TRANS/WP.11/2002/3
22 juillet 2002

**AGREEMENT ON THE INTERNATIONAL CARRIAGE OF
PERISHABLE FOODSTUFFS AND ON THE SPECIAL
EQUIPMENT TO BE USED (ATP)**

Proposed amendment to Annex 1, appendix 1

Transmitted by Transfrigoroute International

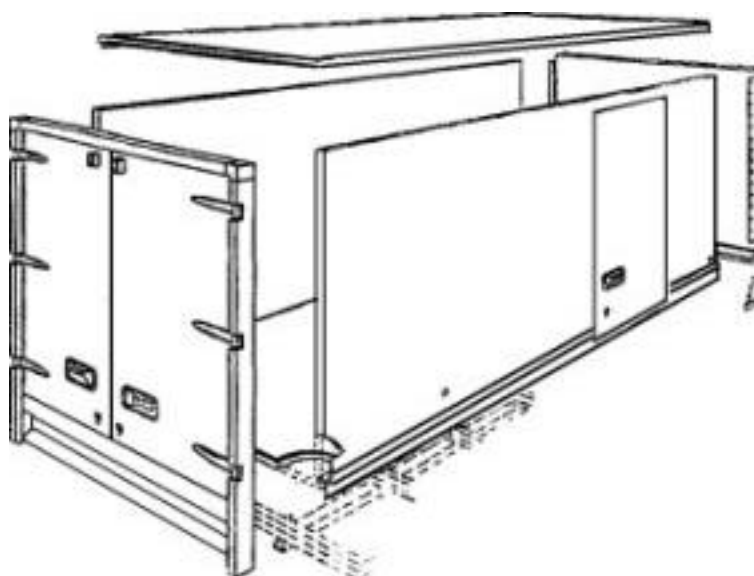
1.1 This procedure can only be used in case of fully prefabricated parts for refrigerated bodies, which are made by the responsible manufacturer including all major parts such as panels, floor, doors, frames etc. See exploded view below:

1.2 Parts of importance to the overall heat transfer, such as door-joints, must be of original brand and type. Parts of no importance to heat transfer, such as protection rails, hinges and meat bars, might be of a comparable brand.
